- 2A. Certified Survey Map to split the current lot located at 14\*\* S. Six Points Crossing (Tax Key No. 454-0651-000) into two lots, submitted by Ian Martin, d/b/a Mandel Group, Inc.
- 2B. Site, Landscaping and Architectural Plans for The Market at Six Points Medical Office Building, a proposed medical office building and clinic, to be located at 6609 W. Greenfield Ave., submitted by Ian Martin, d/b/a Mandel Group, Inc. (Tax Key No. TBD via CSM)

Items 2A and 2B may be considered together.

### **Certified Survey Map**

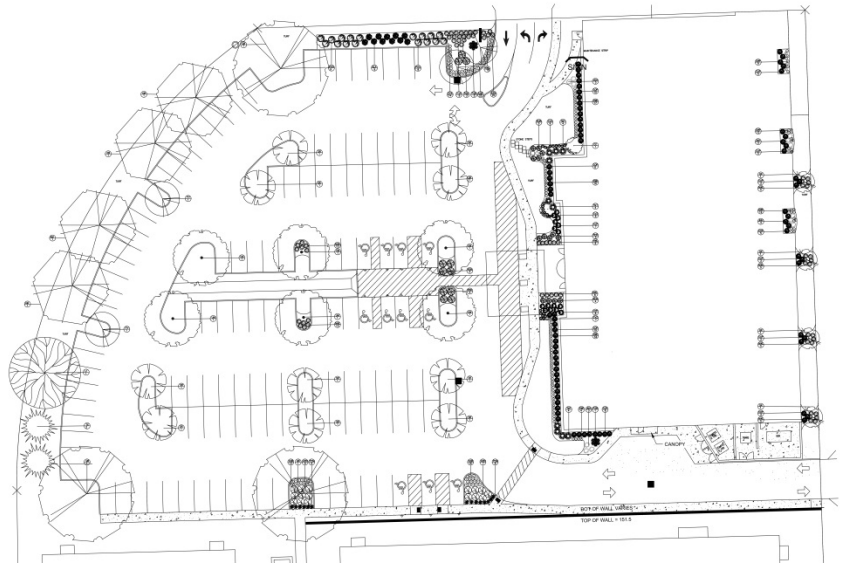
The current parcel is being proposed to be split via a Certified Survey Map into two lots. Lot 1 would comprise of 2.715 acres and be located on the north portion of the parcel, and will be redeveloped with the medical clinic. Lot 2 would comprise of 4.8641 acres on the southern portion of the lot, and will be proposed for redevelopment with a 177-unit apartment building at next month's Plan Commission. Staff is recommending approval of the proposed CSM, as submitted.

Sheet: **EXTERIOR ELEVATIONS**

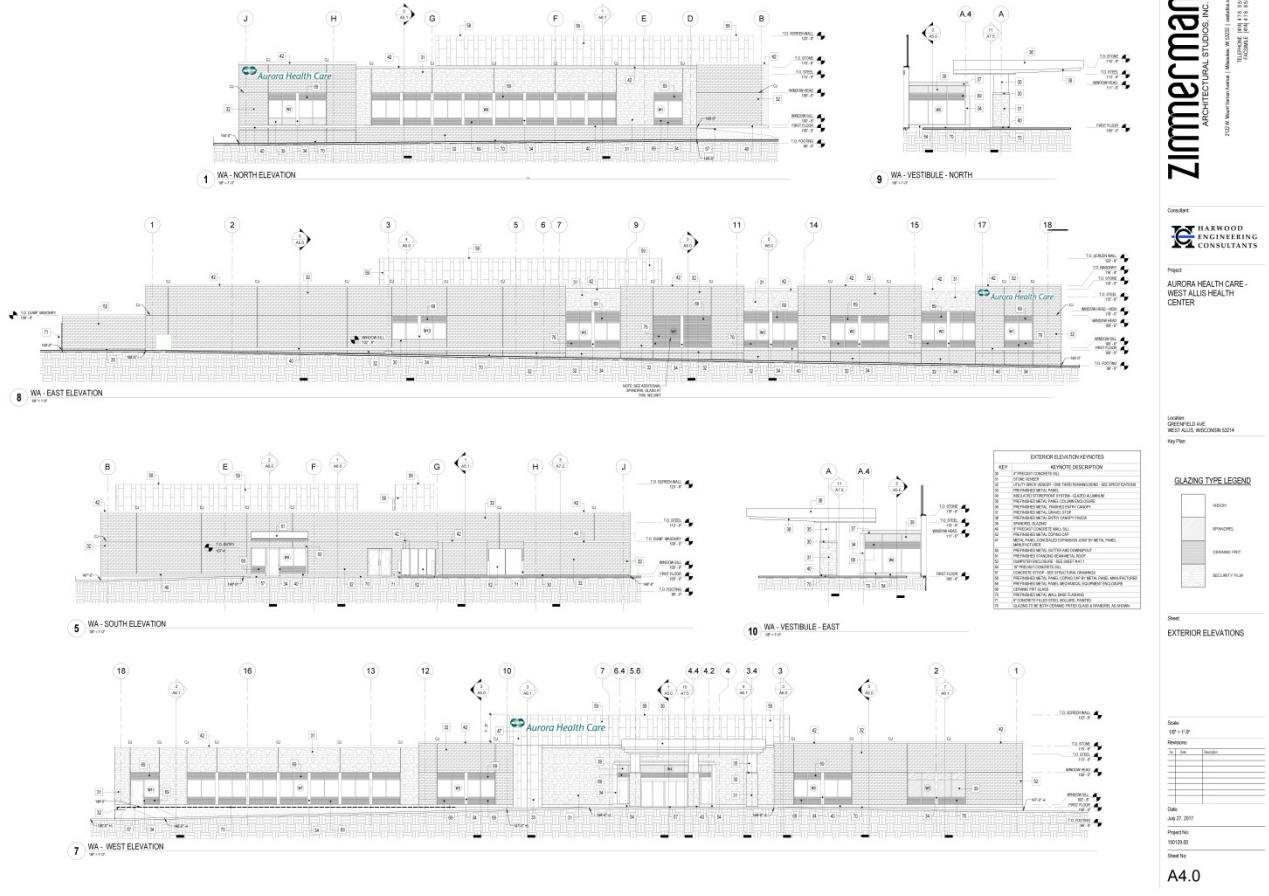
Along the W. Greenfield Ave. street frontage, the stone veneer will be carried around the corner above the horizontal band that acts as a base window sill. For consistency, staff has requested that this stone veneer visually clad the entire area, similar to the corresponding western façade. The applicant has indicated a willingness to work on the concept, possibly by incorporating a landscape box feature. Satisfactory details are being requested as a condition of approval.

The northeast corner of the building is a visually prominent feature of the design, and the applicant has acknowledged this by conceptually placing signage at this location. Staff has asked for greater architectural thought here, possibly through the inclusion of greater height, a roof element, increased materials or expanded windows. The applicant is currently working with their architect to provide an updated concept, which will hopefully be ready by the time of the Plan Commission meeting.

The eastern façade facing S. Six Points Crossing features alternating projections of brick and stone veneer along the front half of the building. Staff has once again recommended that the stone veneer be carried to the base of the building, to offer a more cohesive visual break in the façade. The rear portion of this façade, whose floor plan corresponds to trash, maintenance and mechanical areas, is currently proposed as a large expanse of brick. Staff has asked the applicant to work with their developer to provide greater interest or definition to the area, and has requested an update as a condition of approval.

Moving along to the rear, south side of the building, brick is wrapped around the corner and also featured along the integral refuse/utility enclosure. A set of service doors is located centrally on this façade, aside a more formal entrance to the clinic's pharmacy. This pharmacy door features an aluminum canopy to signify its public entrance. While appreciative of the material quality proposed in this area, staff has suggested that some additional material variation could be added, to help break up the expanse and provide visual interest to the adjacent residential tenants.

1. A revised Site, Landscaping and Architectural Plan being submitted to the Department of Development to show the following: (a) base landscaping along the north elevation of the building; (b) landscaping infill within all parking lot island/peninsulas; (c) the addition of "roof-like" screening atop the refuse area; (d) reduction of the exit along W. Greenfield Ave. to feature one exit lane; (e) details of pedestrian cross access from the south of the development to W. Greenfield Ave.; (f) stone veneer, or similar material/coloring applied to the base of the façade to help offset/accentuate the corner; (g) greater architectural expression of the northeast corner; (h) stone veneer to be carried to the base on proposed building insets; (i) greater material articulation along the south portion of the east façade; (j) greater material variation along the south elevation; (k) consideration of window headers or sun-screens, as architecturally compatible; (l) any other landscaping species/quantities recommendations as provided by the City Forester; and (m) bike parking facilities. Contact Bart Griepentrog, Senior Planner, at (414) 302-8469 with any questions.
